Millstone Nuclear Power Station, Unit No. 3
Response to Requests for Additional Information
Structural and Geotechnical Engineering Branch (SGEB)

Response to Request for Additional Information
Structural and Geotechnical Engineering Branch
Questions 241.23 through 241.26

MILLSTONE UNIT NO. 3
SEISMIC FRAGILITY EVALUATION
WEST RETAINING WALL

MILLSTONE UNIT NO. 3
SEISMIC FRAGILITY EVALUATION
SENSITIVITY STUDY
WEST RETAINING WALL
RESPONSE TO QUESTION 241.23

FIGURE 1
 SHOREFRONT PROFILE USED IN
 LIQUEFACTION ANALYSES
 MILLSTONE NUCLEAR POWER STATION
 UNIT 3

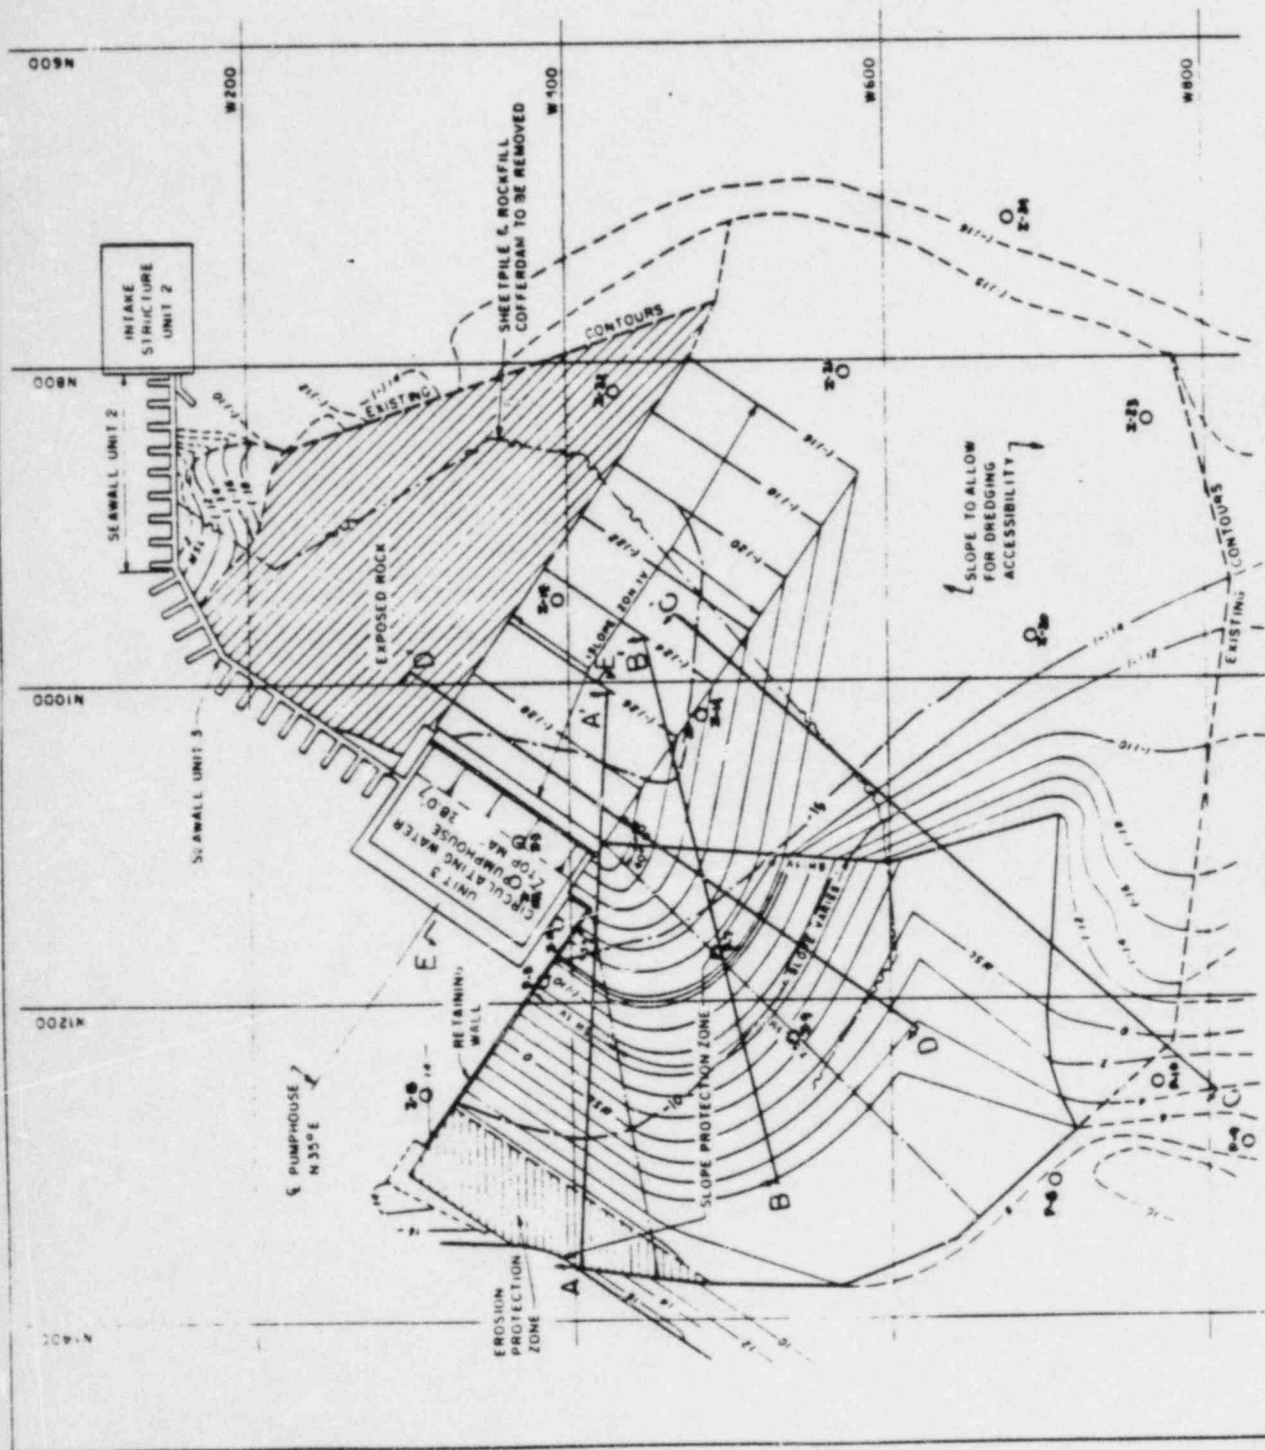
The consequence of seismically induced liquefaction of beach sands is not specifically addressed in the Millstone seismic capability study (Reference 1). The beach sands could be liquefied under seismic events greater than SSE and could flow toward the intake structure, thus preventing an intake structure from conveying the cooling water for the safe shut down. Therefore, provide the analyses for the stability of the beach sand slope and assess its consequences under seismic events greater than SSE.

The circulating and service water pumphouse is located on the shorefront of Long Island Sound, as shown in Figure 2. A liquefaction analysis of the sands underlying the slope protection zone adjacent to the pumphouse was performed using a 2-dimensional dynamic response analysis in response to question 241.7 and is discussed in FSAR Section 2.5.4.8.3.3. Figure 1 summarizes the results of the analysis and presents the factors of safety against liquefaction for the sand zone under SSE conditions. The analysis indicated that an adequate margin of safety against liquefaction existed for the sand zone at the pumphouse. The east slope was not analyzed since it consists of a sloping rock surface with no sand or till layers.

A fragility analysis of the shorefront slope was performed to assess the effects of earthquakes larger than the SSE. The assumption was made that the sand liquefies under a large earthquake of unspecified magnitude. The shorefront consists of a slope protection zone, sand, basal till, and bedrock as shown in Figure 3. This analysis conservatively assumes that the entire zone of sand liquefies simultaneously, causing the sand and overlying slope protection zone to move as a unit towards the intake channel. From the results of the liquefaction analysis under SSE conditions presented in Figure 1, it is expected that liquefaction during larger events would initially occur in the sand at the toe of the slope. The exact location corresponding to initiation and extent of liquefaction could vary depending on the earthquake magnitude. However, it is unlikely that the entire sand zone would completely liquefy; rather, progressive slumping failures would occur as unliquefied sand behind a liquefied zone slumps into the void left by the sliding sand. It is unlikely that sand beyond the top of slope at el 14 ft would be mobilized and able to move sufficiently to block the intake channel because of the orientation of the top of the slope to the intake channel. Therefore, the assumption used in the analysis of massive flow slides initiating at the toe of the slope and moving large distances is very conservative, even under large magnitude earthquakes.

FIGURE Q241.3-4

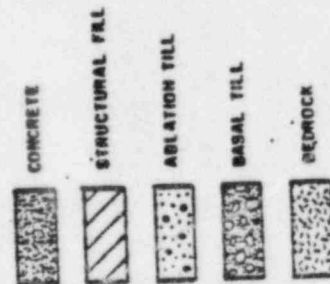
Although it was stated by the staff that the south footing (Figure Number Q241.3-4) appears to be acting independently along with the structure fill, in reality it cannot respond independently due to the rigid box configuration of the structure. It is also noted that the structural fill is confined between the stiff boundaries of control building, the south wall footing and the basal till. In order to maintain the strain compatibilities of the elastic behavior between the boundaries, it forces the confined soil to behave in a manner similar to the behavior of surrounding material. Moreover, since the majority of the structure is founded on basal till, the local fill has no effect on the calculated responses of the structure.
